Final Engineer's Report

Improvement of Judicial Ditch No. 91 Redwood County and Yellow Medicine County, Minnesota

July 2020

Exhibit 2: JD 91 Watershed Map

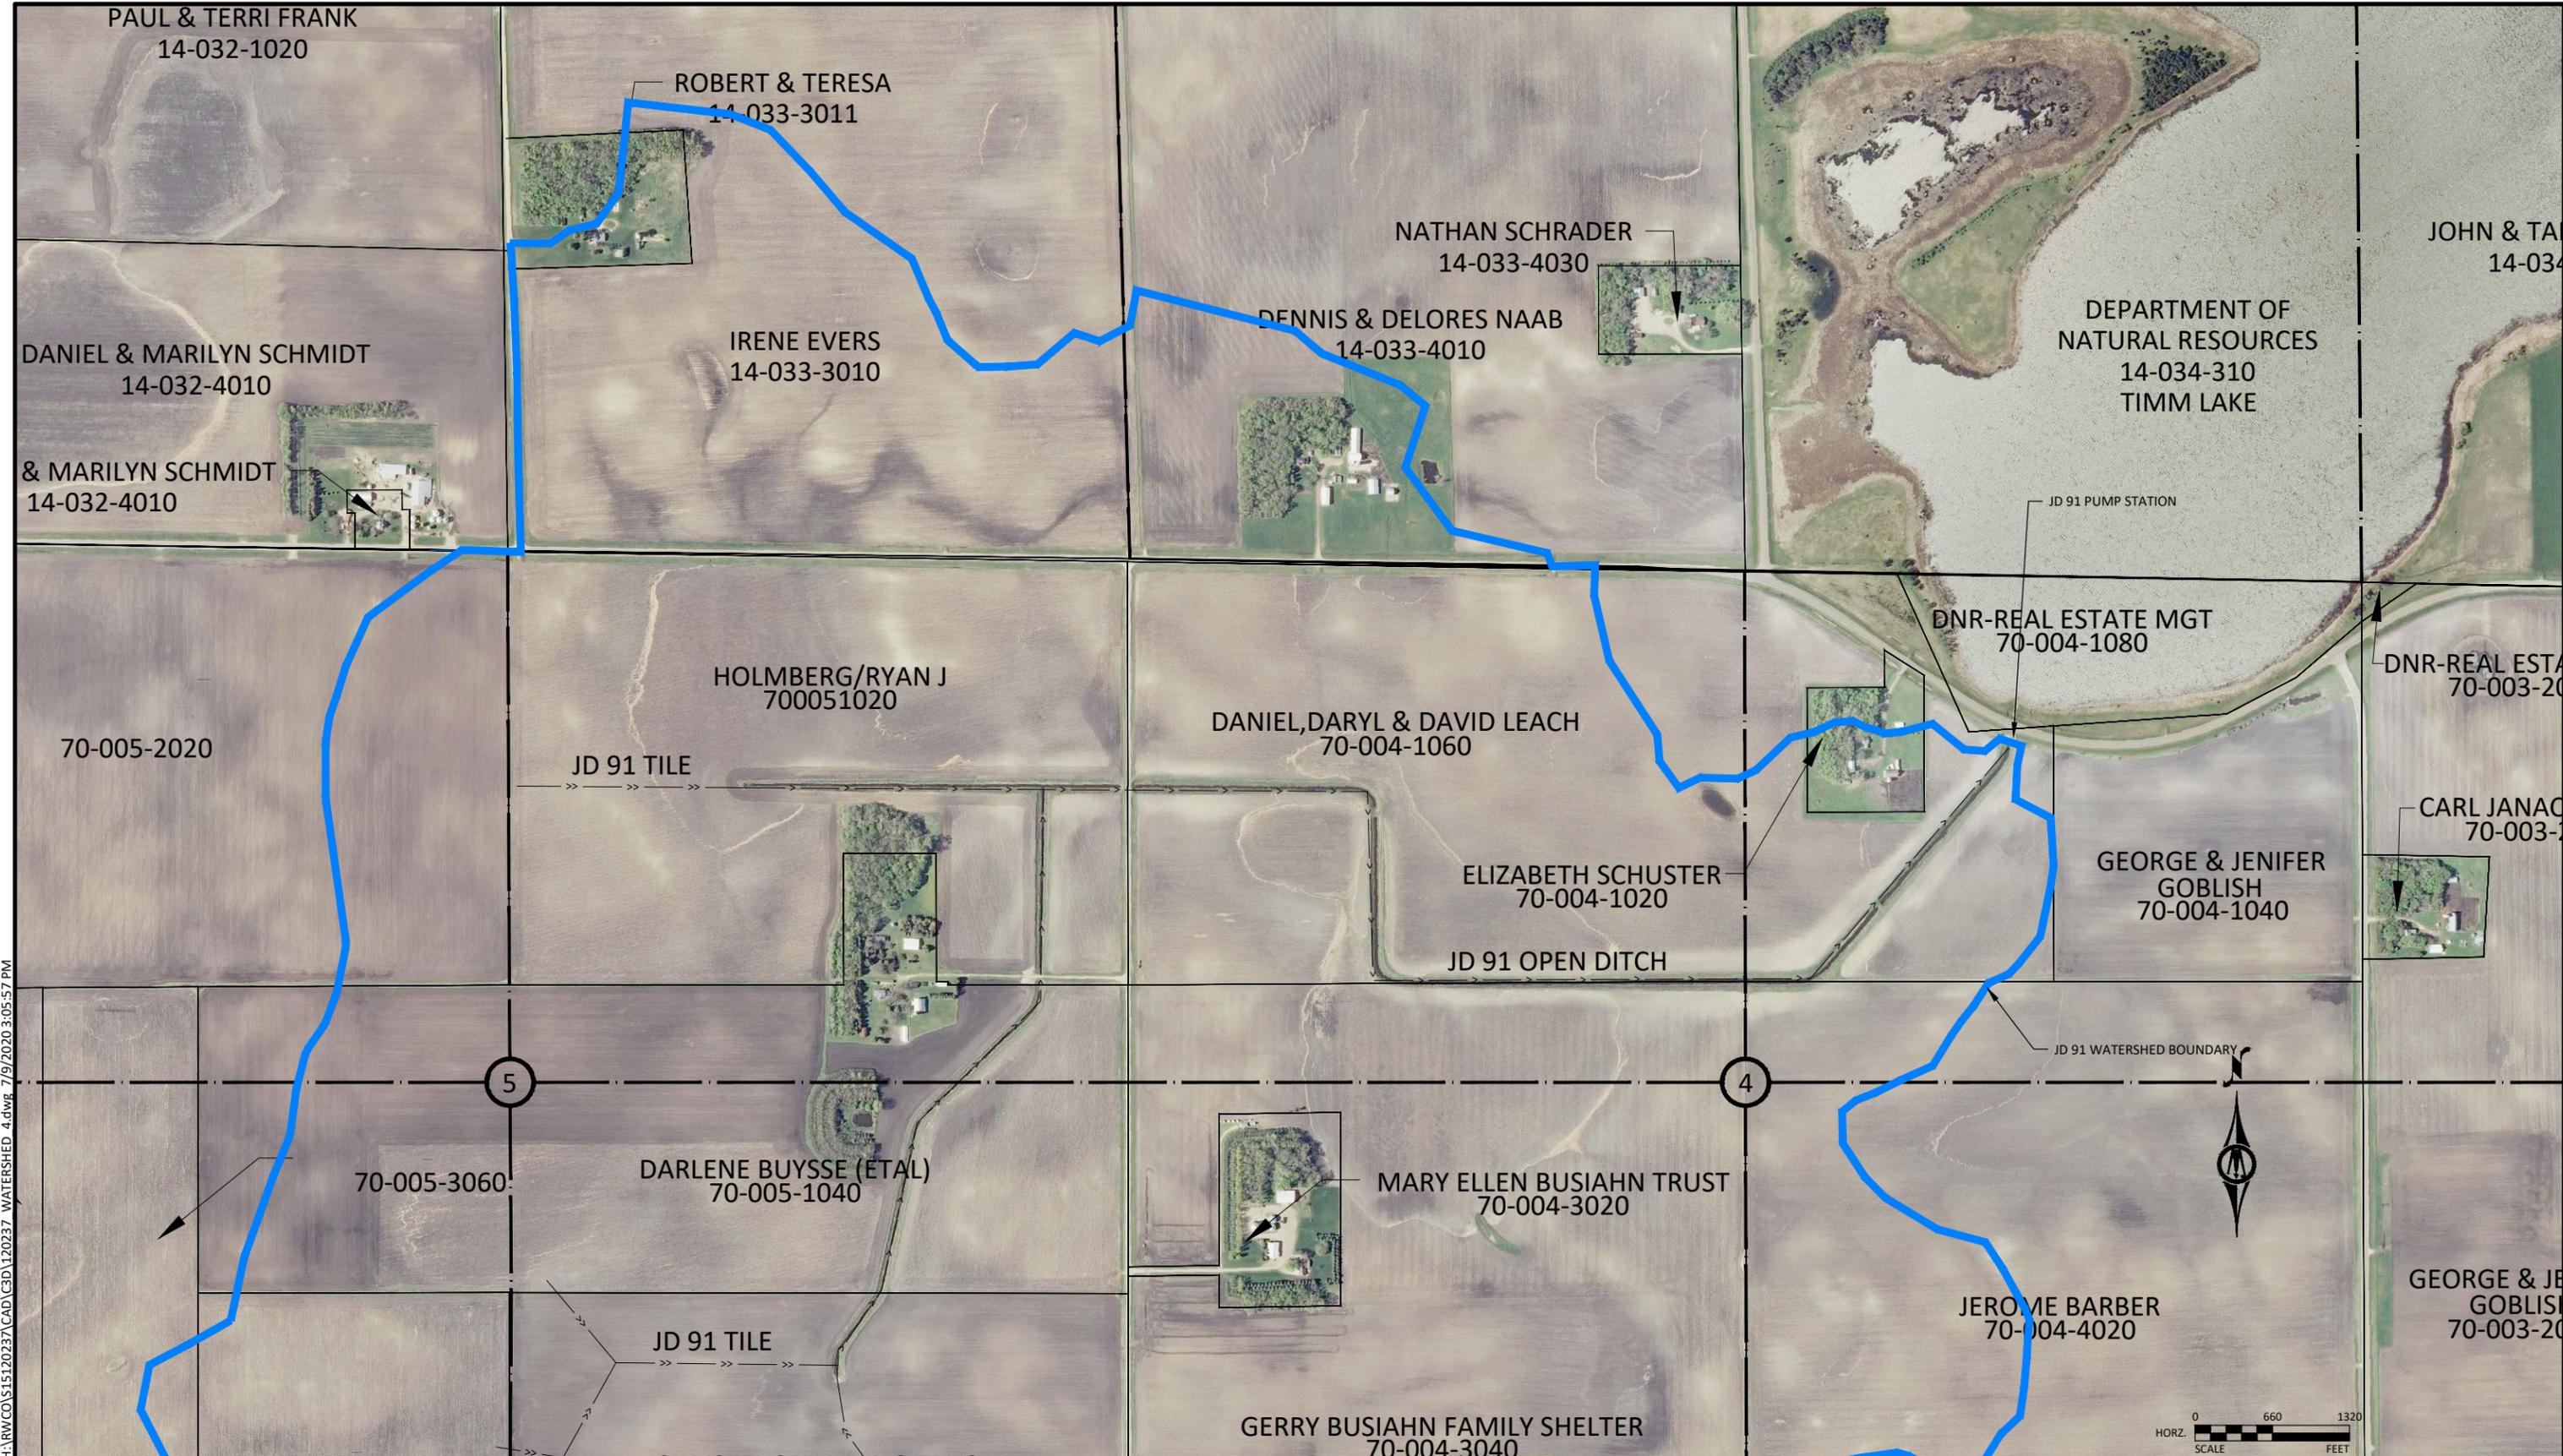
1. The PER does not illustrate the proposed ditch, tile, laterals, outlet, project watershed, property likely to be affected, and affected properties' owners as required in 103E.245 Subd. 4.

1. Exhibit 2 contains the existing ditch watershed boundary and features.
2. Work will not take place north of County Road 46 so no permit will be required from the DNR.
